Technical Guidance Committee Meeting

Thursday, April 18, 2013

Draft Minutes

State of Idaho
Department Of Environmental Quality
Technical Guidance Committee

Figure 4-20. Pump to drop box detail.

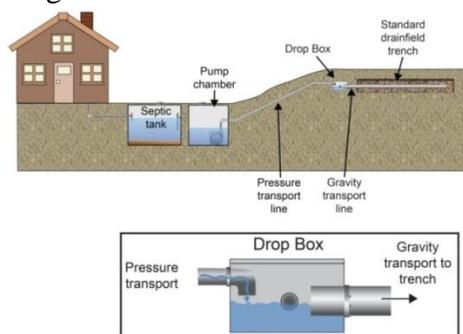
George Miles stated that item number 8 of this proposed section is an engineering function. George Miles stated that pump design is engineering and thus an engineer was needed to design this portion of the system. Without an engineer George Miles stated that the installer and homeowner were relying on computer programs that are not reliable. Discussion followed on how pumps need to be sized and selected for the best performance. The committee discussed the hundreds of pump to gravity systems that are in which were not designed by an engineer. Mike Reno voiced concern over requiring a homeowner to get an engineer to design a pump to potentially lift effluent over very short runs and with little vertical lift. The committee decided that engineering should be recommended under certain conditions which were added to the section. The committee also added the statement that the pump selection is recommended to be performed by an engineer licensed in the State of Idaho.

The committee did not like the proposal of the use of a check valve in the system design. This portion of the proposed section was removed.

7. ~~The pump to drop box system design~~ Pump and transport pipe design/selection may require engineering (Idaho Code 54-1202.10 defines pump selection as an engineering practice) based upon the regulatory authority's judgment. Pump design/selection ~~should~~ shall be performed by an engineer licensed in the State of Idaho when elevation gains of greater than 20 feet or lengths of 100 feet are exceeded in effluent transport.

Figure 3-3. Overhead view of equal distribution methods.

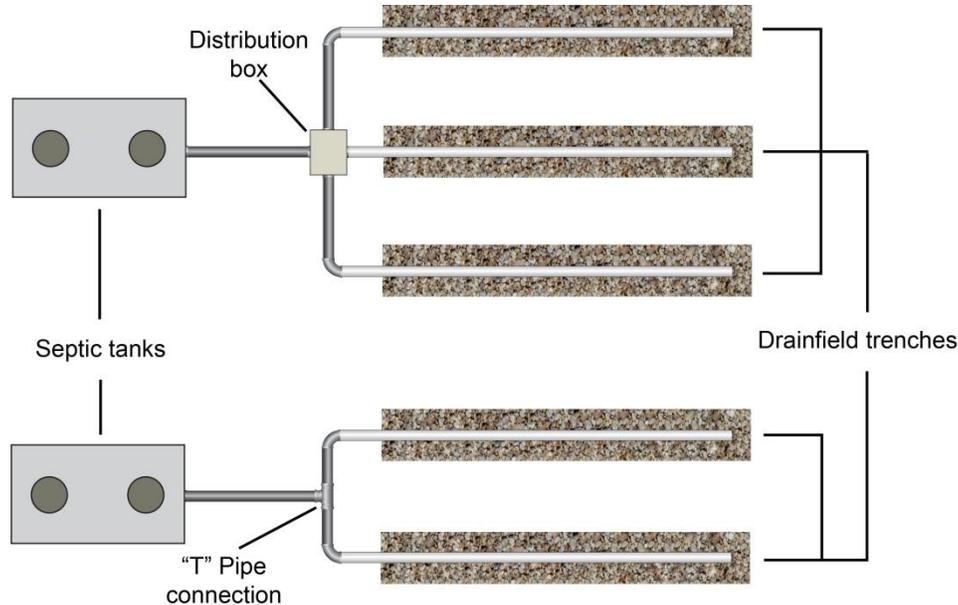
The proposed additions of these sections were at the request of the committee. The material used to develop these sections was derived from the EPA Onsite Wastewater Treatment Systems Manual as requested by the committee. The committee made some recommendations to limit the use of serial distribution and asked that the figure under the piping header section be changed to two trenches instead of 3.

With a piping header system wastewater is conveyed to each disposal trench through the use of a network of solid piping. The discharge line from the septic tank should be split through the use of a T pipe fitting. The T should be offset equally from the distribution trenches. One-directional sweeping cleanouts should not be used in place of a bi-directional T. The T pipe fitting should be installed on a solid surface in a level position. It is recommended that the piping header only be utilized in installations involving two trenches. See figure 3-3 for an overhead view of this distribution setup.

Figure 3-1. Dimensional-Horizontal separation distance requirements for a standard drainfield (IDAPA 58.01.03.008.02.d and 58.01.03.008.04).

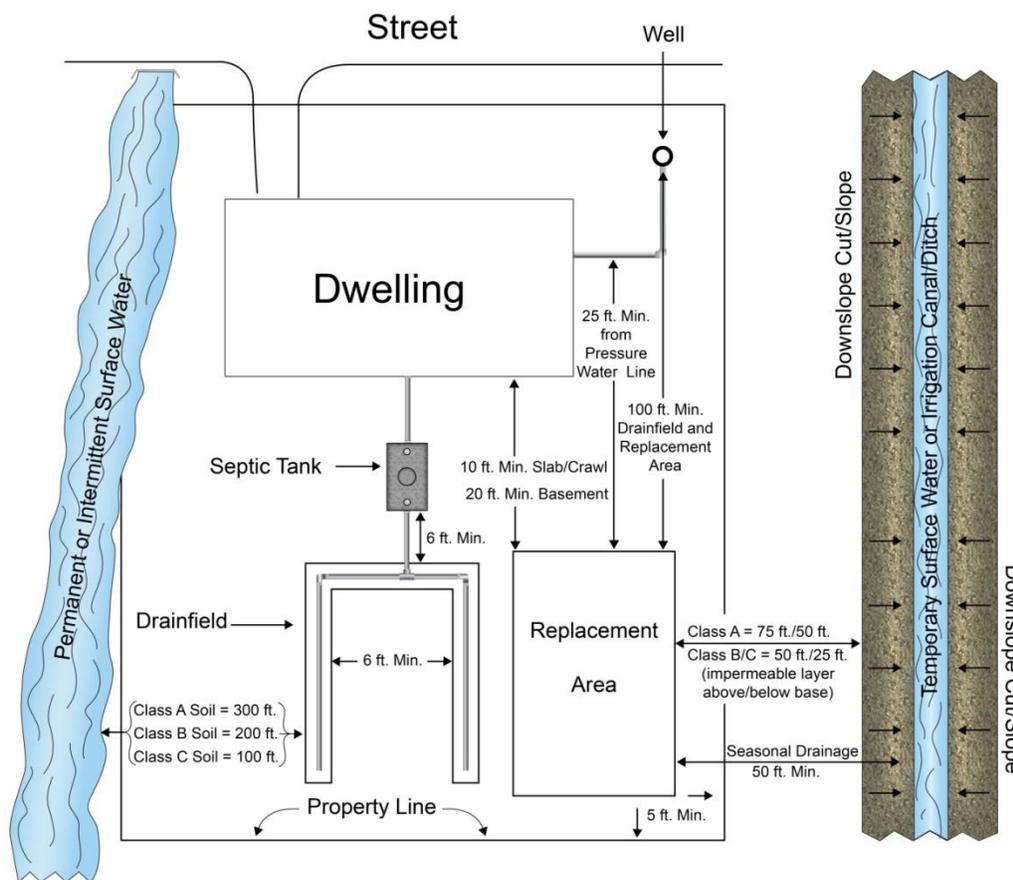
Figure shows the **major dimensional-horizontal separation distance** requirements for a standard drainfield. **Figure 3-1** shows the **major dimensional-horizontal separation distance** requirements for a septic tank.

1. ~~Distance~~ Minimum separation distance of 20 feet is required between ~~from~~ a drainfield ~~to~~ and a dwelling with a basement ~~is 20 feet~~ (IDAPA 58.01.03.008.02.d). If the basement is a daylight style basement and the drainfield installation depth is below the daylight portion of the basement the minimum separation distance can be reduced to 10 feet.
2. Minimum separation ~~distance~~ of 6 feet is required between absorption trenches and from installed trenches or beds to the replacement area ~~(IDAPA 58.01.03.008.04)~~. Separation distance must be through undisturbed soils (IDAPA 58.01.03.008.04).

Figure 3-1. Dimensional-Horizontal separation distance requirements for a septic tank (IDAPA 58.01.03.007.17).

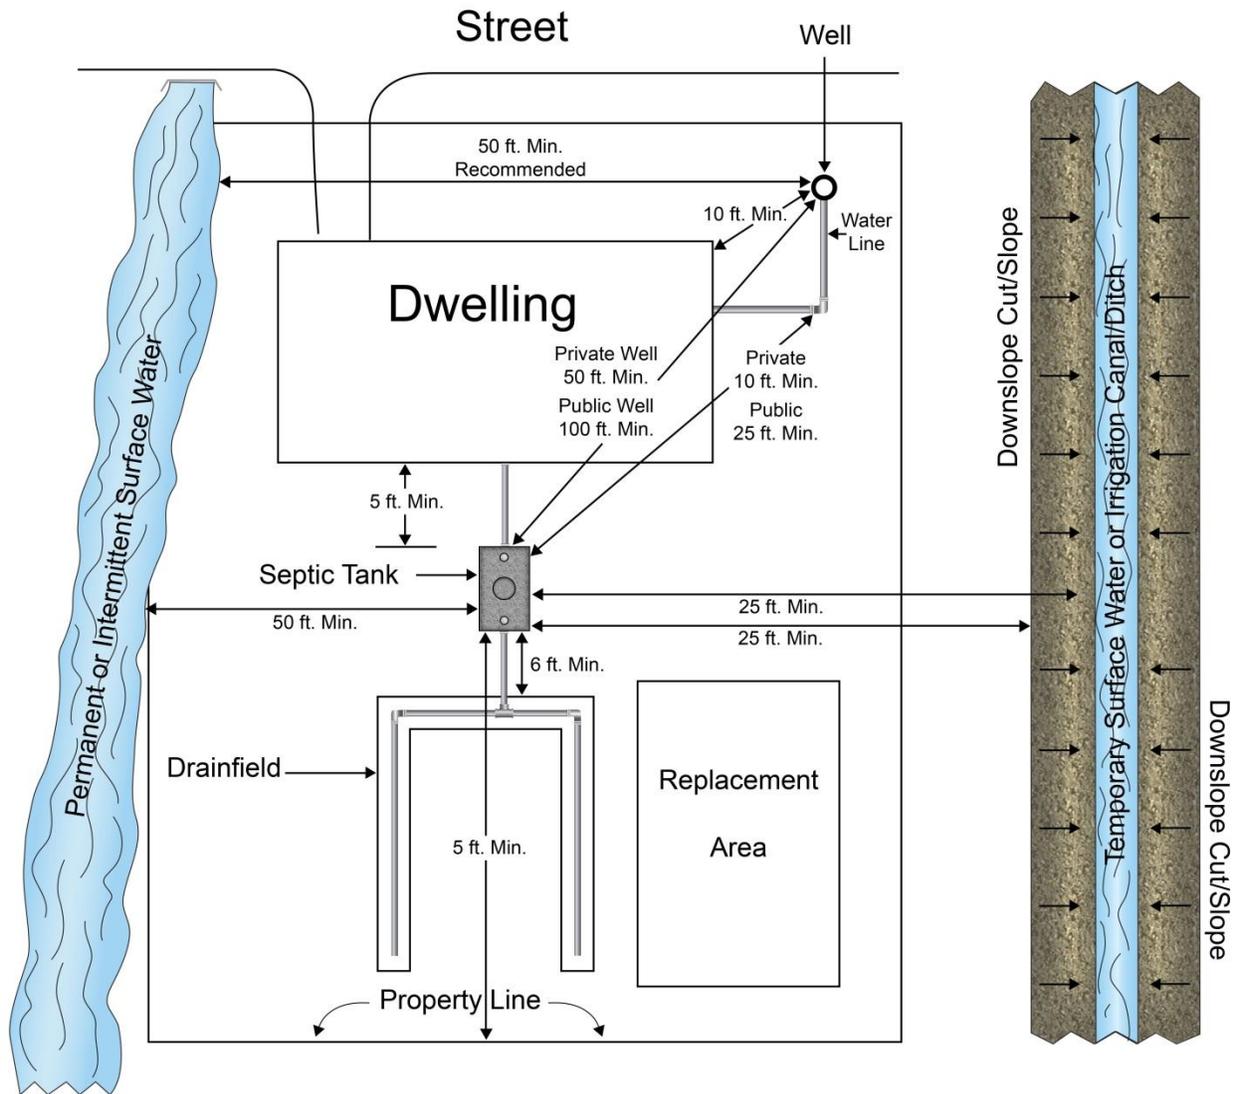
3. ~~Distance~~ Minimum separation distance of 6 feet is required ~~from~~ between the septic tank ~~to~~ and the drainfield ~~is 6 feet (IDAPA 58.01.03.008.04)~~. Separation distance must be through undisturbed soils (IDAPA 58.01.03.008.04).
4. Minimum separation distance of 50 feet is required between a building sewer line, effluent pipe, and a septic tank ~~to~~ and a domestic well ~~is 50 feet (IDAPA 58.01.03.007.17 and 58.01.03.007.22)~~.
